Product Change Notification

Date Issued :
 May 26, 2022
 PCN Number :
 512103

PICOLOCK1.5/2.0 APPLICATION TOOLING SPECIFICATIONS

Before Picture

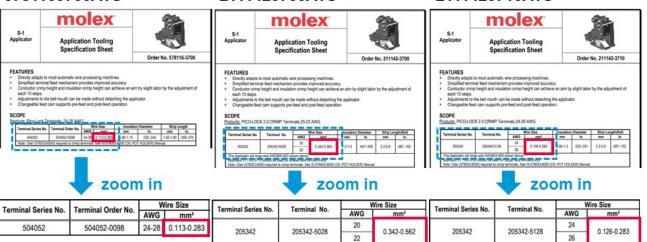
Change value to 0.089-0.227

Change value to 0.342-0.523 Change value to 0.141-0.221

- Change description
 - The Wire size mm² on the Application Tooling Specification will be changed;
 - -5781163700ATS: From 0.113-0.283 to 0.089-0.227
 - -2111423700ATS: From 0.342-0.562 to 0.342-0.523
 - -2111423710ATS: From 0.126-0.283 to 0.141-0.221
 - The Wire size mm² value corresponding to the AWG value can be calculated by formula. However, since the current value was calculated by the incorrect formula, we will correct the value.
- Product Impact
 - This change affects Application Tooling Specification Document Only
 - No impact to product
- Part Number Impact
 - •504052 series and 205342 series
 - ·see attached impacted parts list for detail
- · How the change implement: Drawing revision update
